Amendments to the Drawings

Attachments: Replacement Sheet 1
Annotated Sheets 1-2 Showing Changes

FIG. 4b

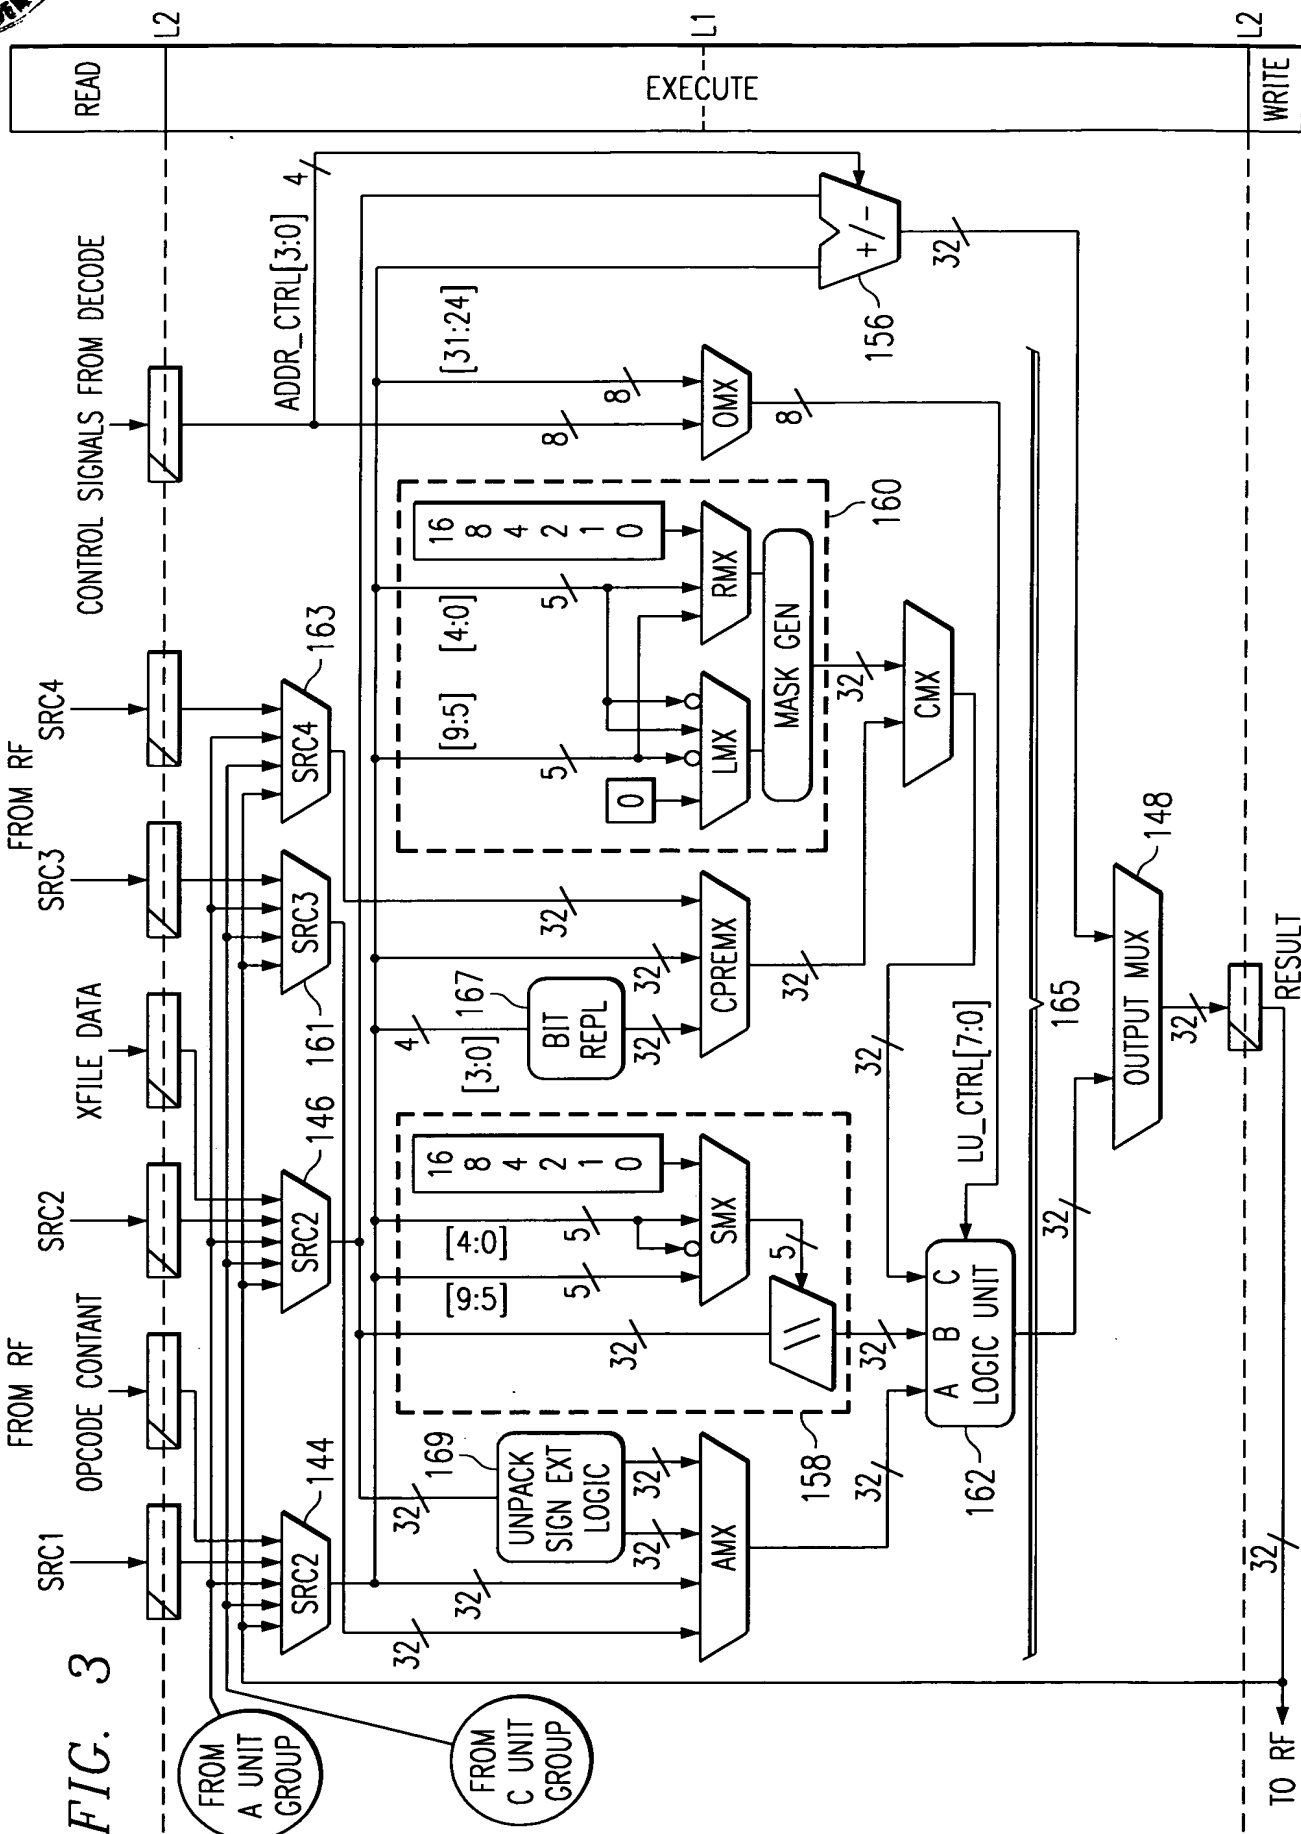
The attached sheet of drawing 1 includes changes to Figure 4b. Figures 6a and 6b have been deleted. Sheet 1 which includes Figures 4a, 4b, 5a, and 5b, replaces the original sheet including Figures 4a, 4b, 5a and 5b. In Figure 4b, variable N extending from pipeline stage PS to DC has been added. The original sheet including Figures 6a and 6b has been eliminated. Figures 6a and 6b have been deleted and are no longer present in the application.
